Findings of Fact | Site Plan Review

Property Address: 294 Lincoln Ave.

Application #: LU-24-225

**Re: Site Plan Review – Response to TAC
Assessor's Map 130, Lot 24
294 Lincoln Avenue
Portsmouth, New Hampshire
Altus Project No. 5548
LU-24-225**

**GRADING & DRAINAGE
PLAN**

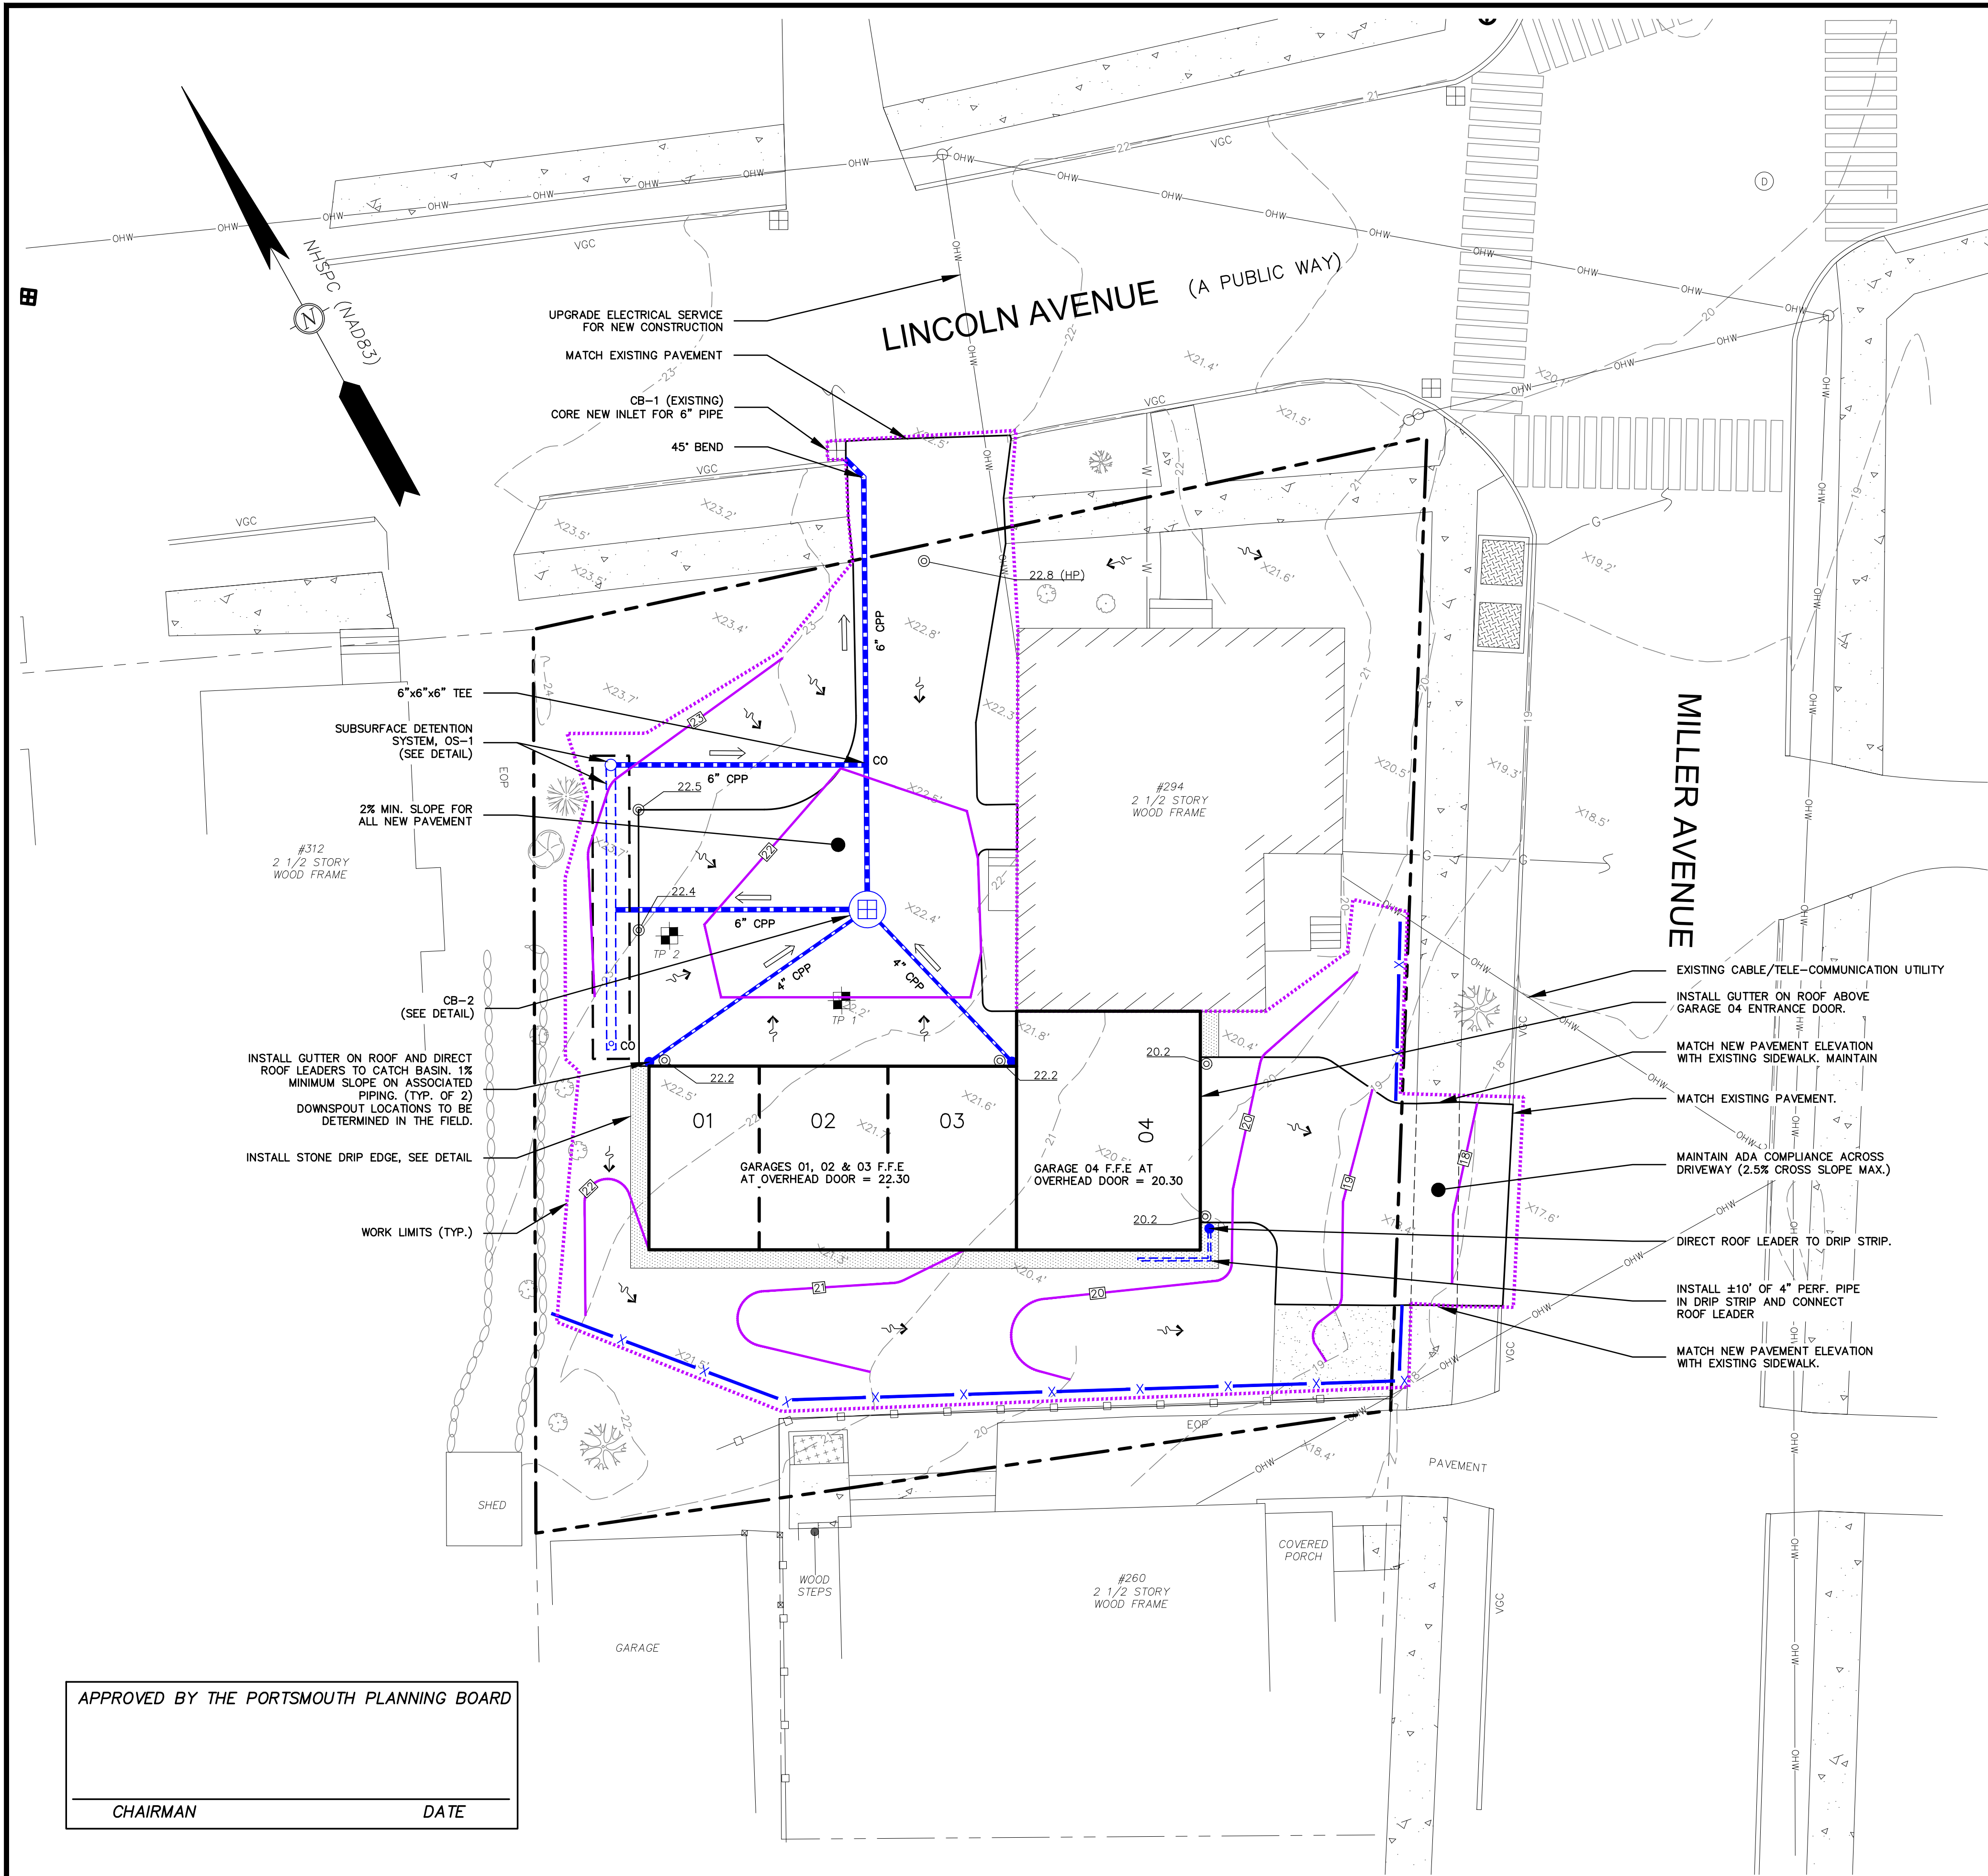
1. “Prior to submission to the Planning Board, applicant shall share the test pit results with DPW to confirm that the drainage study is accurate.”

Two test pits were completed in the area intended for the new drainage system, test pit locations and results are provided on sheet C-3. Test pits confirmed that the ground is suitable for an infiltration drainage system however the location of the system has been changed. The revised location and system is also presented on sheet C-3 and the drainage analysis has been revised accordingly.
